GATWICK AIRPORT NORTHERN RUNWAY PROJECT

PLANNING INSPECTORATE'S REFERENCE: TR020005

RESPONSE TO ACTIONS RAISED BY THE ExA AT ISSUE SPECIFIC HEARINGS 9

POST-HEARING SUBMISSION INCLUDING WRITTEN SUMMARY OF THE LEGAL PARTNERSHIP AUTHORITIES ORAL CASE

Figure 2: Average summer night additional aircraft noise-induced awakenings versus LAeq,8h for Gatwick 2014 (modal split 60% west/40% east, 123.1 total movements, 78.8 arrivals and 44.3 departures)

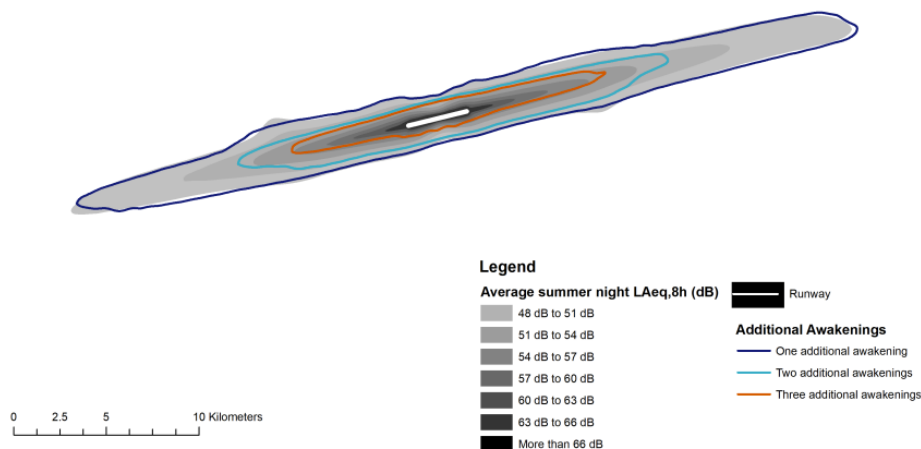
1. The contour for one additional noise induced awakening will not necessarily coincide with the 48 dB LAeq8h contour and the two should not be conflated.

At Gatwick Airport (Figure 2 reproduced below) there is a reasonably good association between the 48 LAeq 8h and one additional awakening contour. This is based on single runway operations. However, the association is not as strong as at Stanstead (Figure 4 reproduced below) so even under single runway operation it is not possible to conclude that the association between the 48dB LAeq8h and the one additional awakening will remain constant. The association at Heathrow is even less (Figure 3 reproduced below) and it shows the effect of dual runway operation at that location. Should the DCO be granted and the Airport resort to dual runway operation, then there is no guarantee that the association will remain as it is now and more likely it will depart from the 48 dB LAeq 8h. For this reason, the additional noise induced awakening needs to be specified separately to the 48 dB LAeq 8h contour.

Figure 4: Percentage of respondents calculated as highly sleep disturbed as a function of average summer night LAeq,8h

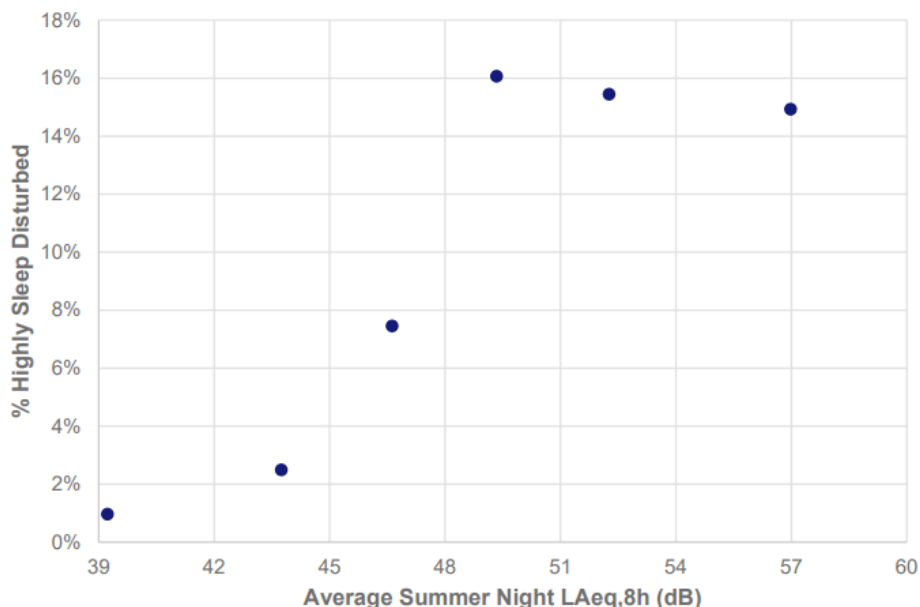
In the Local Impact Reports the JLAs all considered that the 48 LAeq8hr night is material, and all acknowledge the potential for the 55 dB LAeq 8h night to underestimate the health impacts. However, there were three authorities who, based on 48 dB LAeq8h went further and advocated the 48 dB LAeq8h as a SOAEL given the interpretation of the exposure response function in Figure 4 of in CAP2161 reproduced below.
